Agenda
Village of Arlington Heights
Design Commission
Community Room, 3rd Floor

Arlington Heights Village Hall
33 S. Arlington Heights Road
Arlington Heights, IL 60005
June 26, 2018
6:30 PM

MINUTES OF
THE VILLAGE OF ARLINGTON HEIGHTS
DESIGN COMMISSION MEETING
HELD AT THE ARLINGTON HEIGHTS MUNICIPAL BUILDING
33 S. ARLINGTON HEIGHTS RD.
JUNE 12, 2018

1 GARAGE/BREEZEWAY WEST ELEVATION
A-4 1/4" = 1'-0"

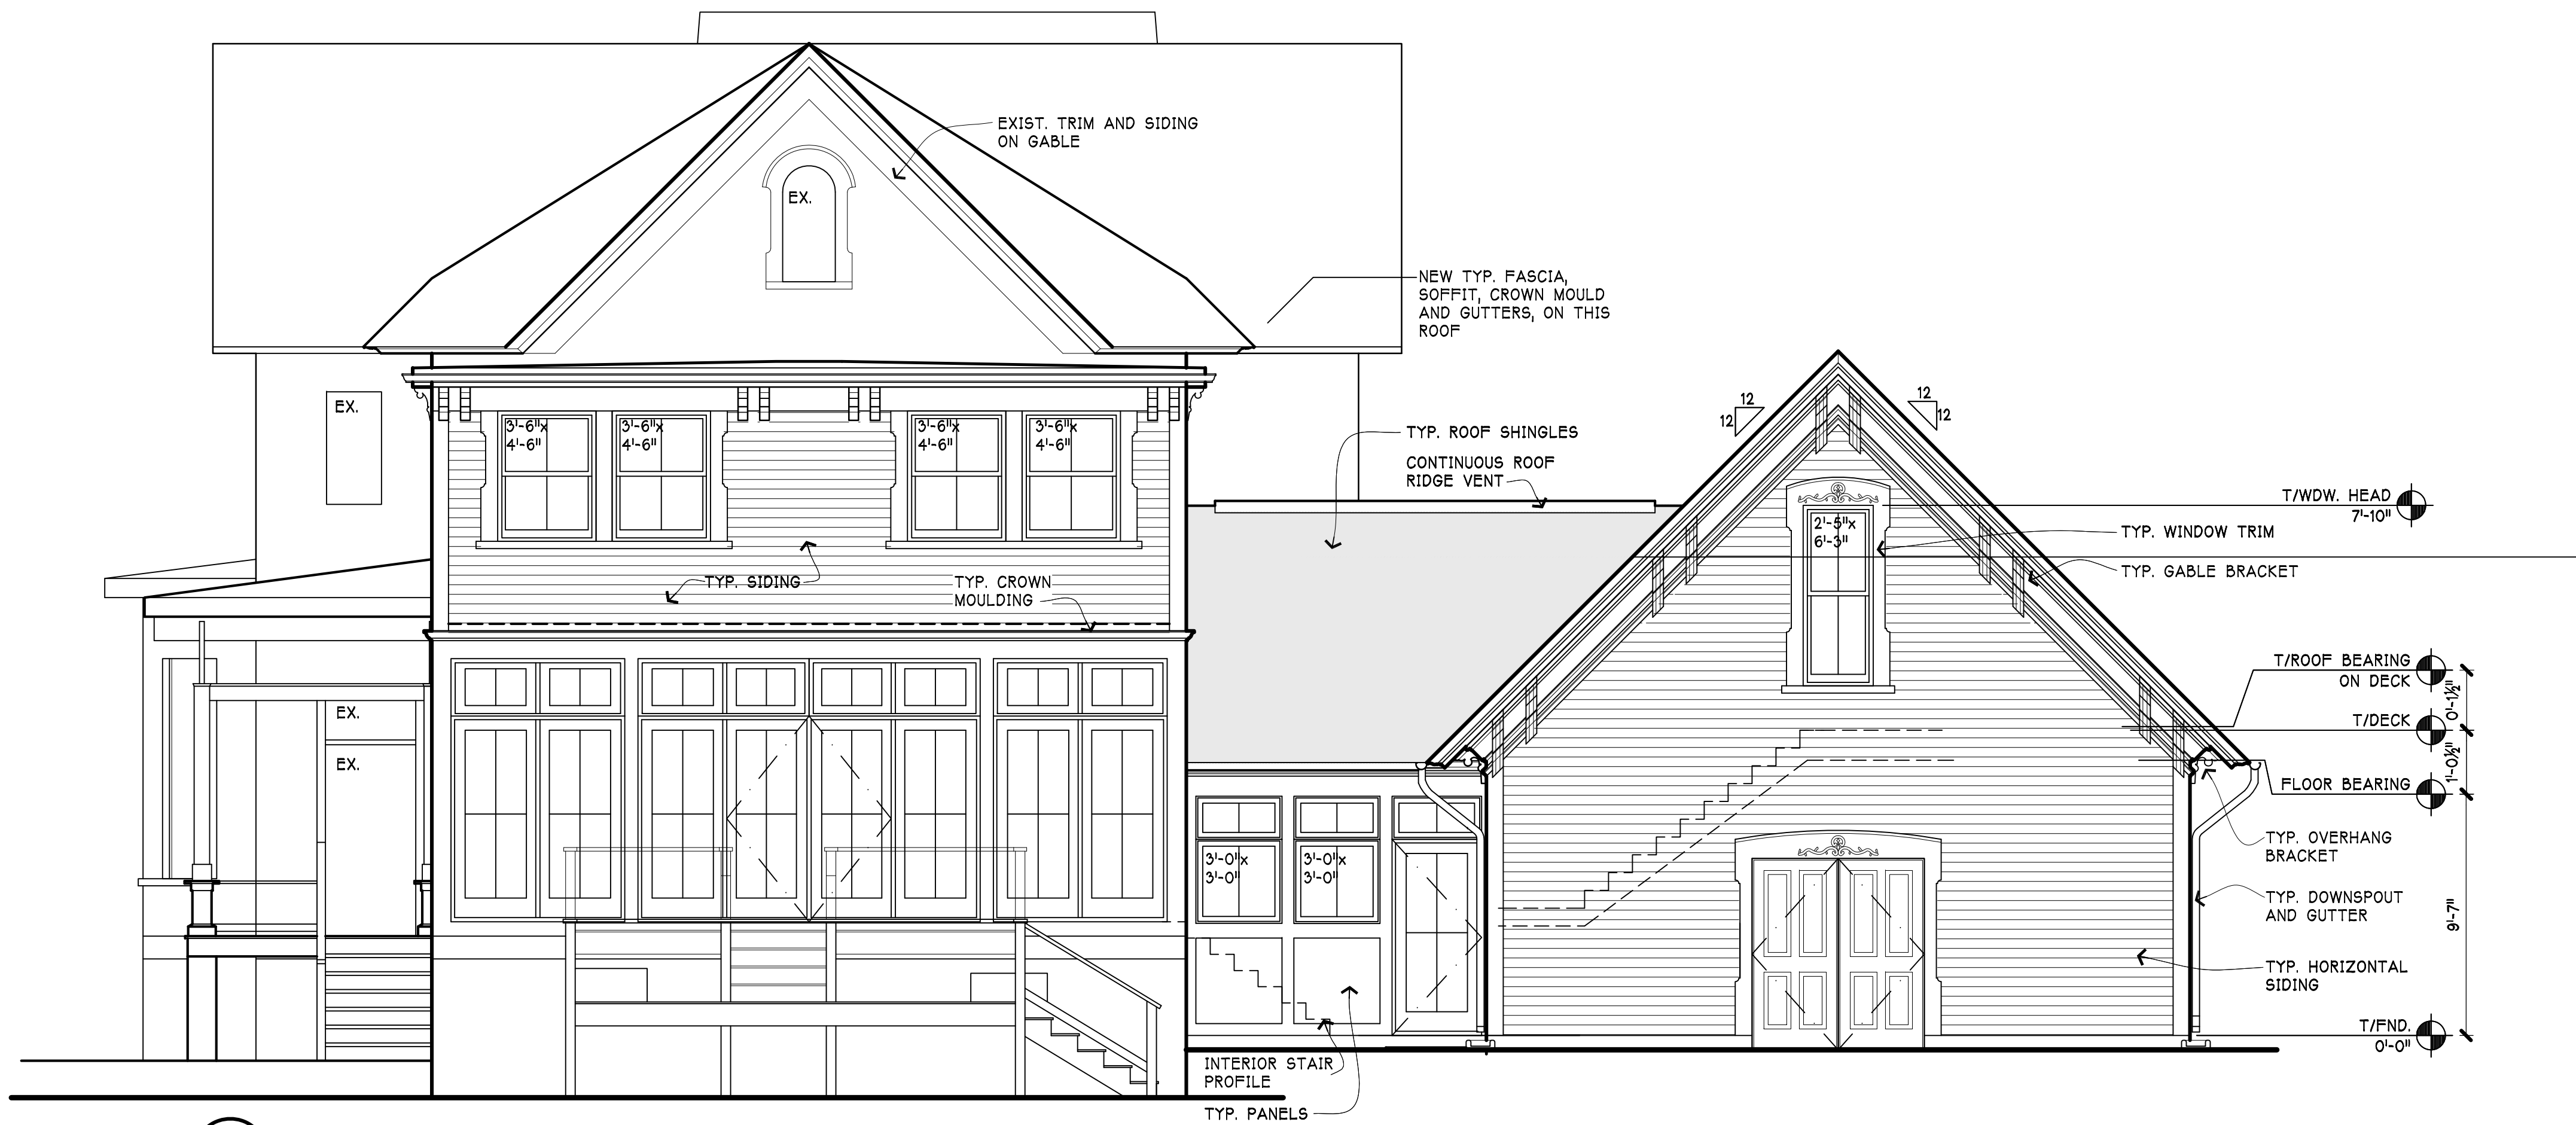
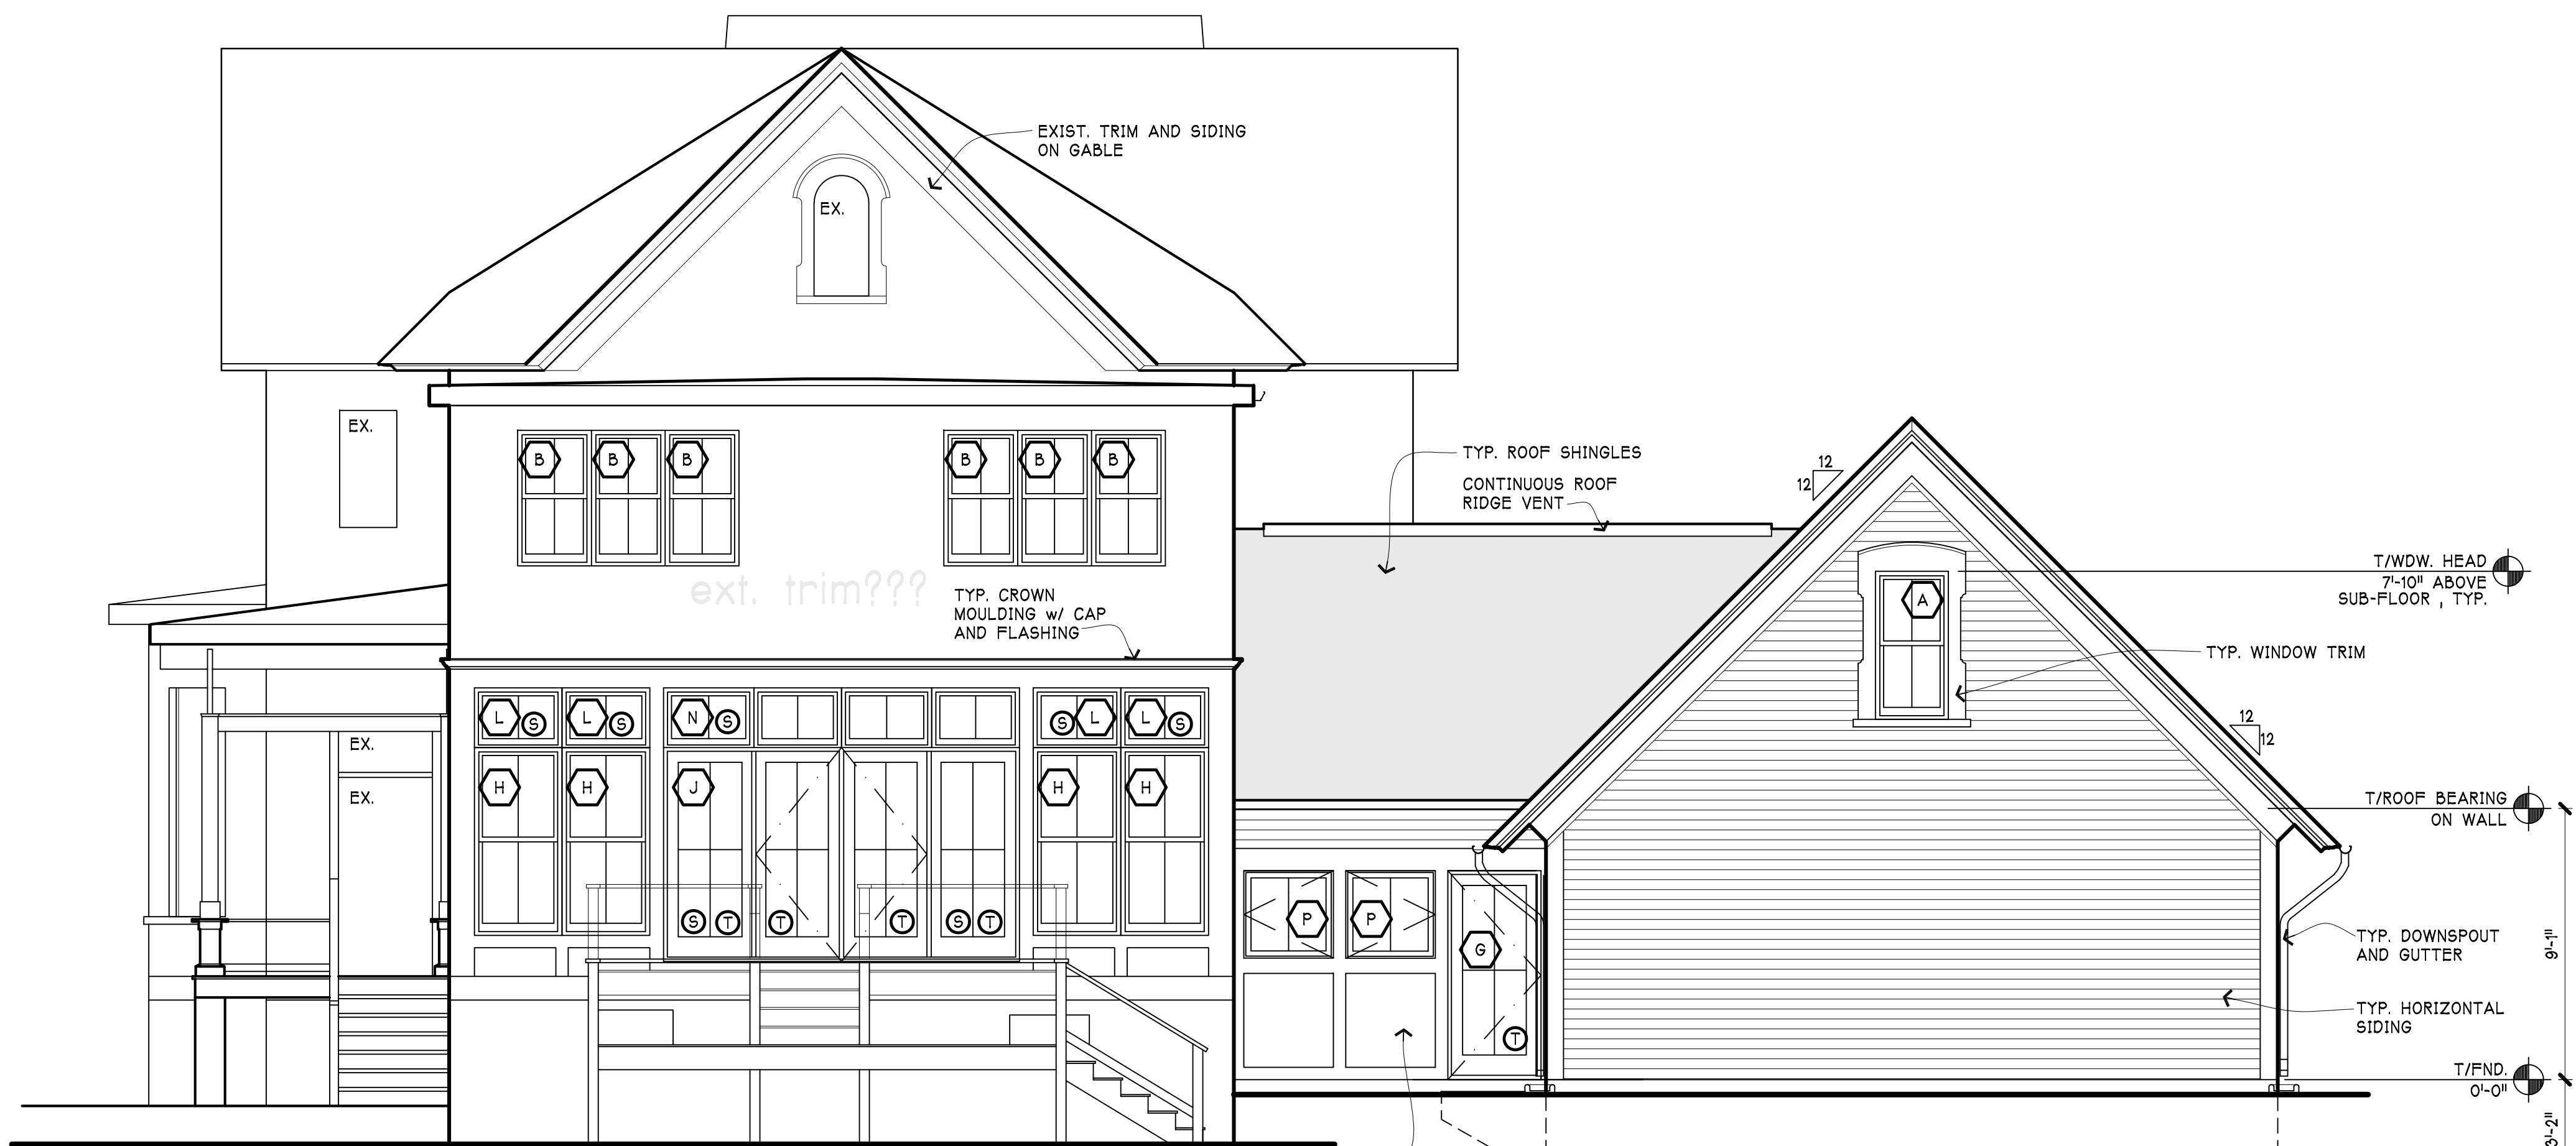
The revised design still fits in very well with the existing house. The massing of the garage, detailing of doors and windows, and detailing of the overhangs and eaves are all very nicely done to complement the existing house. The garage addition is substantially set back from the front of the house which creates the appearance of a detached garage, and it is questionable whether the decorative brackets and mouldings would be visible from the street. Overall, the design is still very nicely done.

It is recommended that the Design Commission **approve** the proposed addition to the existing single-family residence located at 619 N. Arlington Heights Road. This recommendation is subject to compliance with the revised architectural plans dated and received 6/7/18, and the following:

1702
06.20.18
AC-7

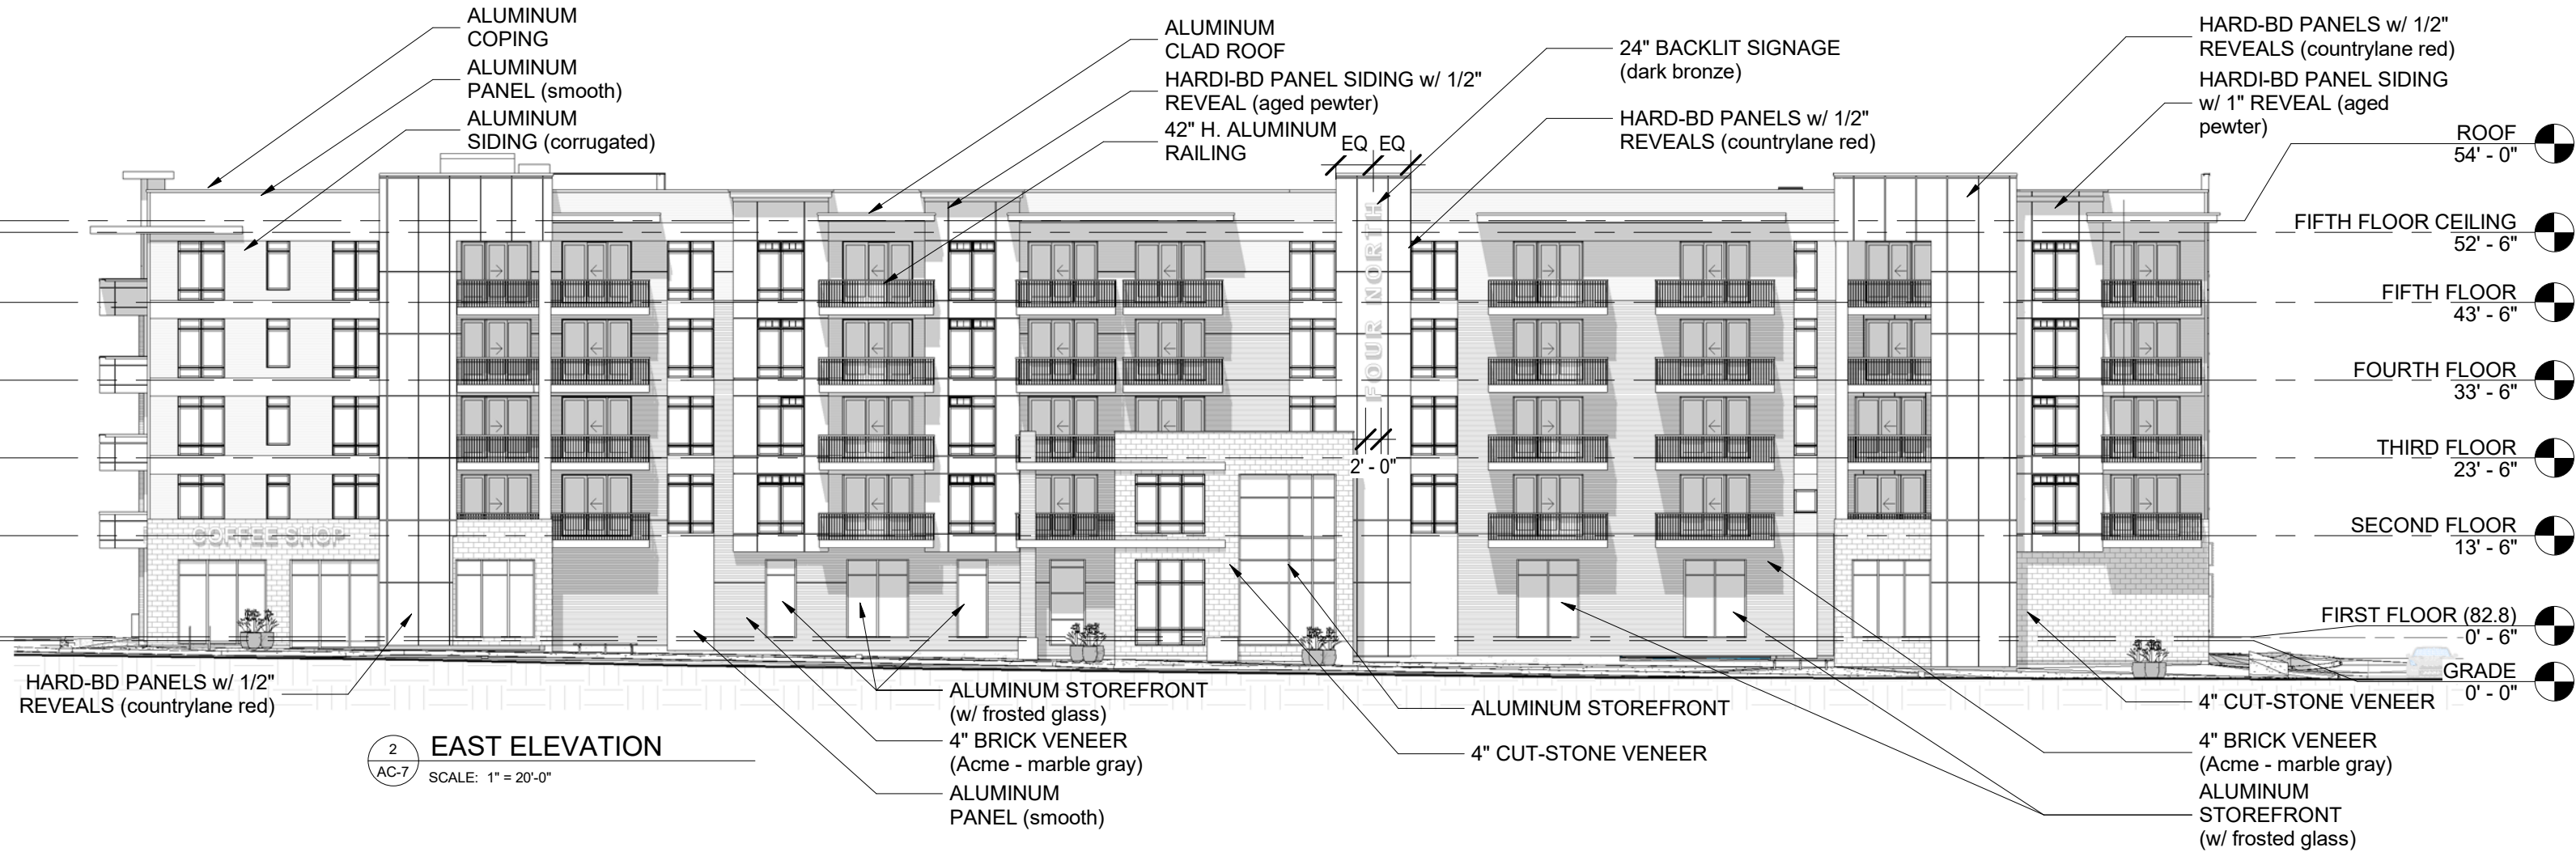
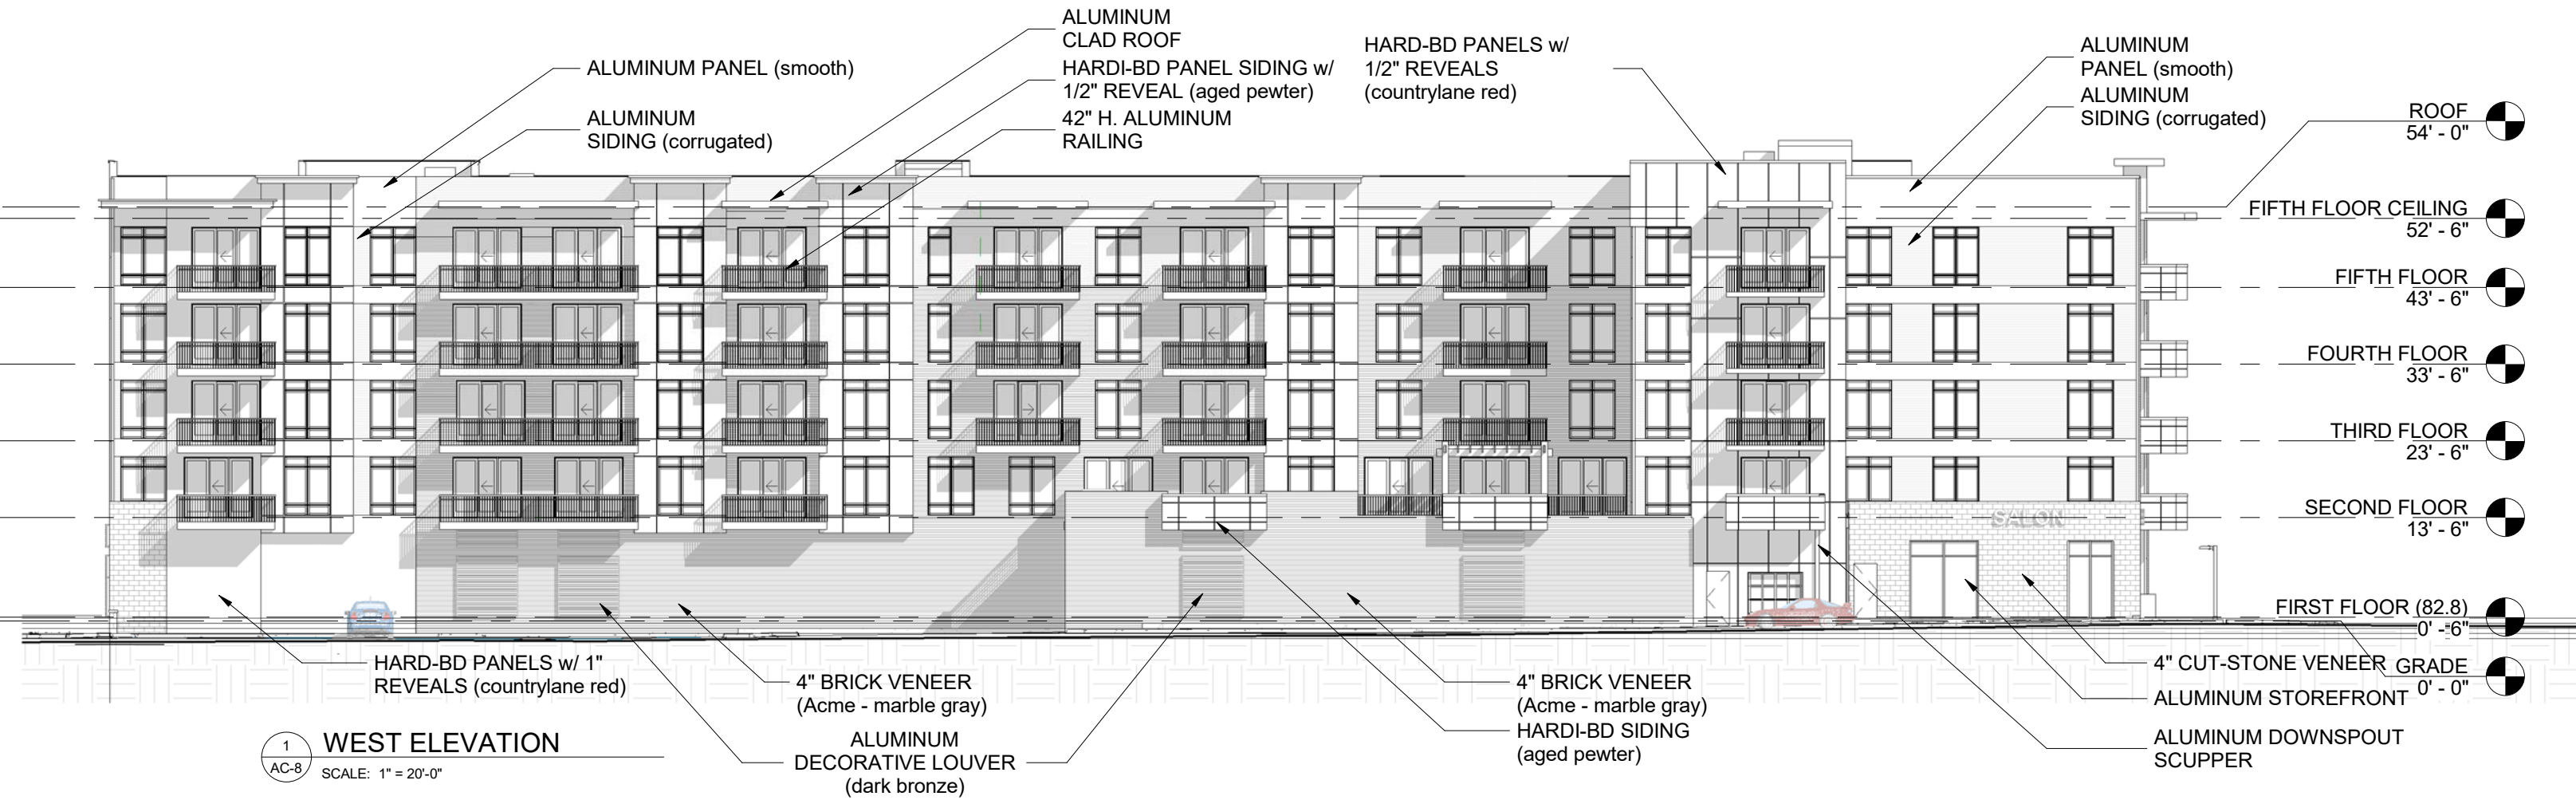
- The petitioner has added a new bumpout on the right side of the east elevation to match the left side, which works well to break up the long flat wall.

It is recommended that the Design Commission approve the design of the mixed-use building to be located at 4 N. Hickory Avenue. This recommendation is subject to compliance with the revised plans dated and received 6/20/18, Design Commission recommendations, compliance with all applicable Federal, State, and Village codes regulations and policies, the issuance of all required permits, and the following:
